Concept – Mech Wheels

Early Concept –Wheels

12.30.2017

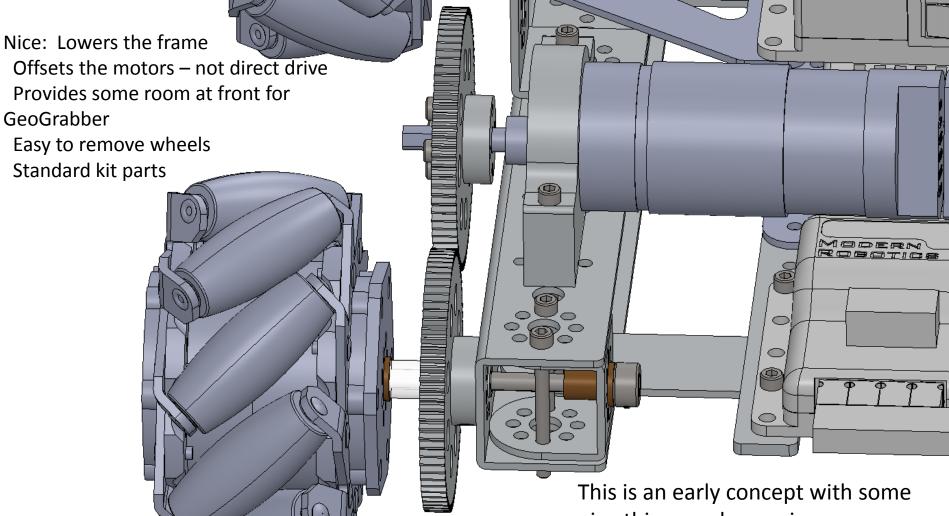
Issues: Lower the frame

Offset the motors – not direct drive

Provide room between motors for wiring

Lower the wheels motors – clearance for Flip motor travel

Provide room at front for GeoGrabber

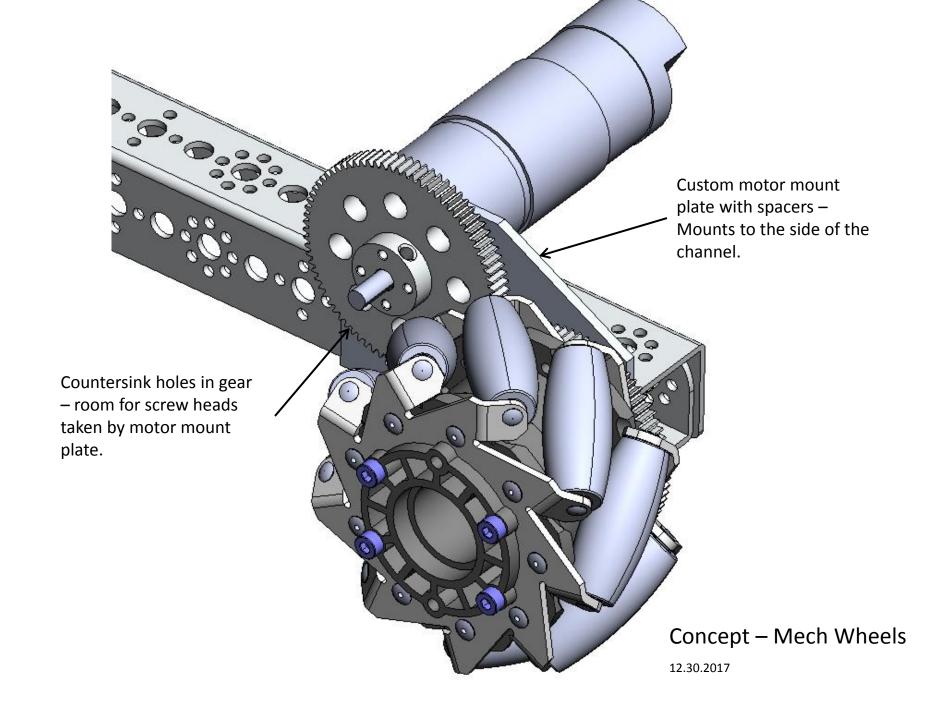
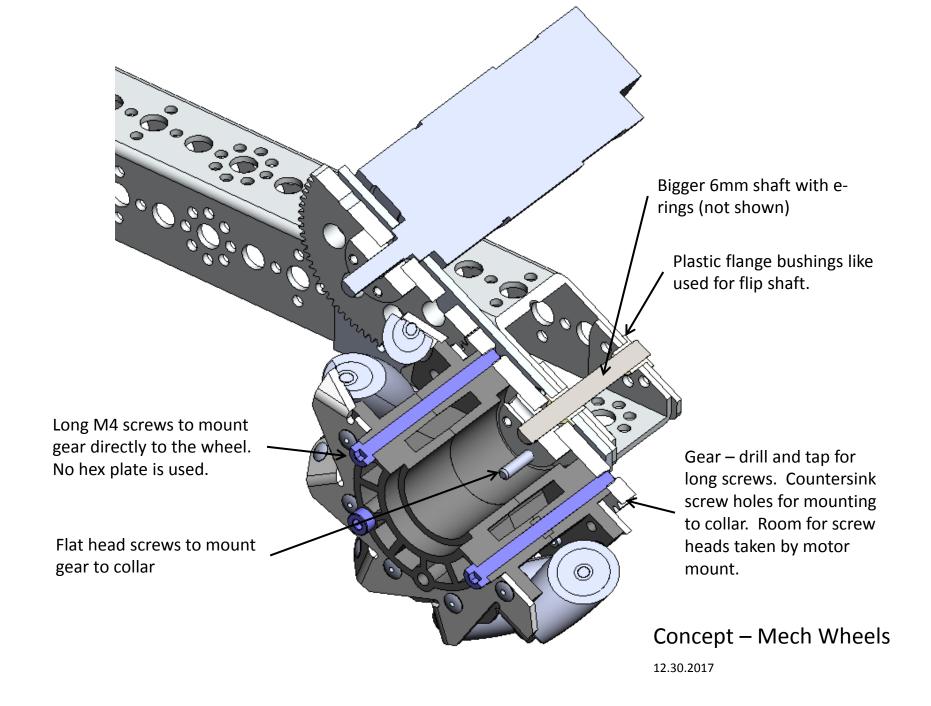
Not nice: Very long slim shaft – bendie.

Wheels a long way from the frame – larger footprint, less maneuverable.

No room between motors for wiring
Wheels motors are high - no clearance for Flip motor travel

nice things and some issues.

Todays concept is a re-thinking of this concept to address the issues
